LEAK OF RADIOACTIVE LIQUOR IN THE FEED CLARIFICATION CELL AT BNG THORP SELLAFIELD

REVIEW OF THE MANAGEMENT AND TECHNICAL ASPECTS OF THE FAILURE AND ITS IMPLICATIONS FOR THE FUTURE OF THORP

CLIENT: GREENPEACE INTERNATIONAL

REPORT REF N° R3123-A2

Accountancy Tank B – Nozzle Failure

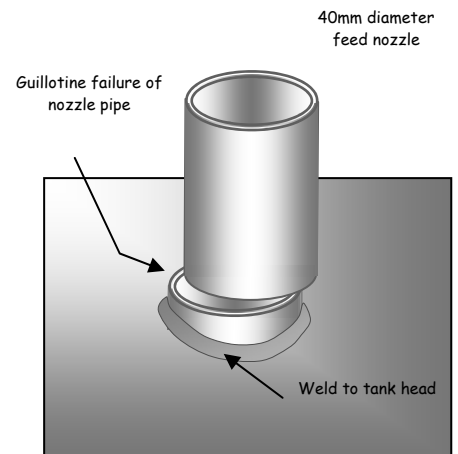
Following the detection of the leak, an internal BNG Board of Inquiry³ reported in May 2005 states that remote cctv inspection of Cell 220 revealed a significant quantity of dissolver liquor in the base of the cell and that a feed pipe to one of the accountancy tanks (Tank B – nozzle N5) had failed by fatigue fracture at a location close to the head of the vessel.

The failure of the feed nozzle is in the form of a complete guillotine break of the 40mm diameter feed pipe just above the pipe to tank welded joint, with the disconnected pipe remaining slightly misaligned above the stub of the pipe. Because of this alignment, the gravity flow of the clarified feed liquor continued to run into the tank, with some of the flow splashing out and running down the tank side, spilling onto sections of the supporting steel frame.

iv) Accountancy via Tank A Only

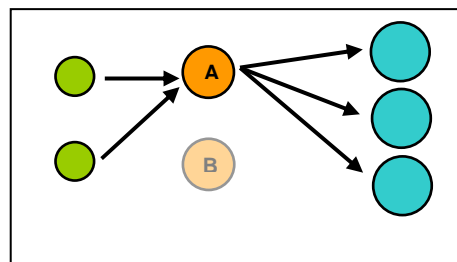
The damaged accountancy tank B is abandoned and the process continues operating only via the present Tank A, albeit with the amended procedure that the tank would only be lifted and suspended when weighing is required, although this option seemingly ignores the potential fatigue to the analogous nozzle N5A.

The use of just one accountancy tank would reduce THORP operational throughputs from in excess of 5 tonnes per day to 3 tonnes per day.

Even if the present continuous suspension mode for accountancy weighing is abandoned, further use of Tank A must be conditional on the fit-for-purpose condition of its nozzle and pipe connections. Before this option can proceed, these connections will have to be robotically inspected and subject to non-destructive examination. This is because Tank A has been in service and subject to the same conditions that failed the N5 connection to Tank B with at least the Tank A N5 connection being subject to the same number of sway and oscillatory fatigue cycles as its failed counterpart.²¹

v) Tank A as Intermediate Stage Only

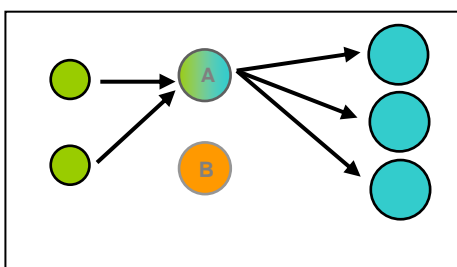
Tank A is utilised as a pump-through reservoir with accountancy being undertaken in the buffer tanks which enables the 5 tonne daily throughput to be maintained.

Tank A remains in use as a collecting and pump through reservoir, with accountancy being completed in the buffer tanks, thereby maintaining the 5 tonne daily throughput for THORP.

APPENDIX I – FRAME DAMAGE

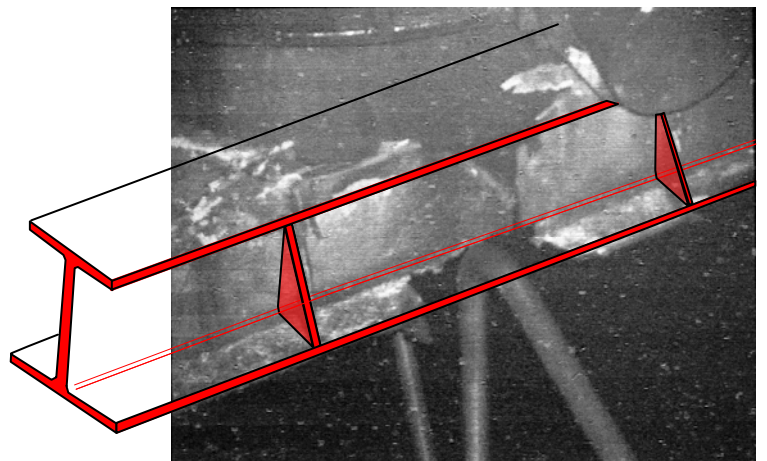
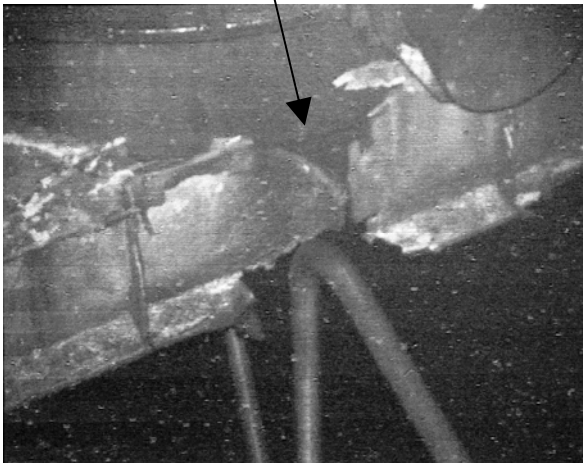
Adequacy of Seismic Restraint Frame: Three of the principal members of the structural frame have been severed (see APPENDIX I) with other damage to the vessel trimmers and a further structural member of the frame.

The NDA's overall assessment is that ". . . *the support frame local to Tank B renders the frame inadequate for future use at all*" so, unless modifications are undertaken to strengthen the frame in the locality of Tank B, the Tank B tank must remain suspended in a safe and stable state irrespective of whether it is ever returned to use.

For future operation of Tank A, the NDA concludes that if the fully charged Tank A was lowered on to the frame then the frame members and joint welds would be overstressed unless, that is, two additional structural support hangers were installed to reinforce the restraint frame. However, the provision of additional hangers to supplement the strength of the corroded seismic frame is technically challenging and presently under consideration as an active contingency by NDA.
